UNITED STATES PATENT AND TRADEMARK OFFICE

Office Action Summary	Application No.	Applicant(s)
	10/762,434	BELCHINE, WALTER
	Examiner Carlos Lugo	Art Unit 3676

DETAILED ACTION

Attachment #1

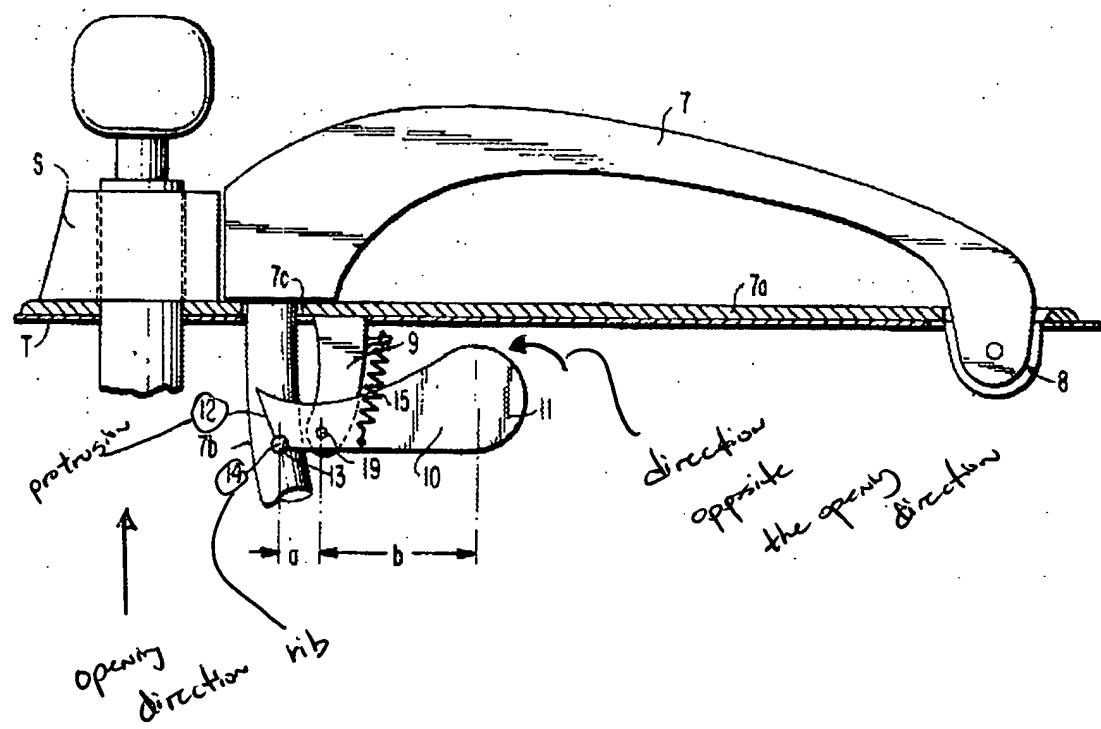
The lever arm moves about a lever axis (19). The handle arm includes a rib (14) and the lever arm includes a protrusion (edge of 12 with 13) to restrict movement of the latch lever about the lever axis without movement of the handle (see attachment #1).
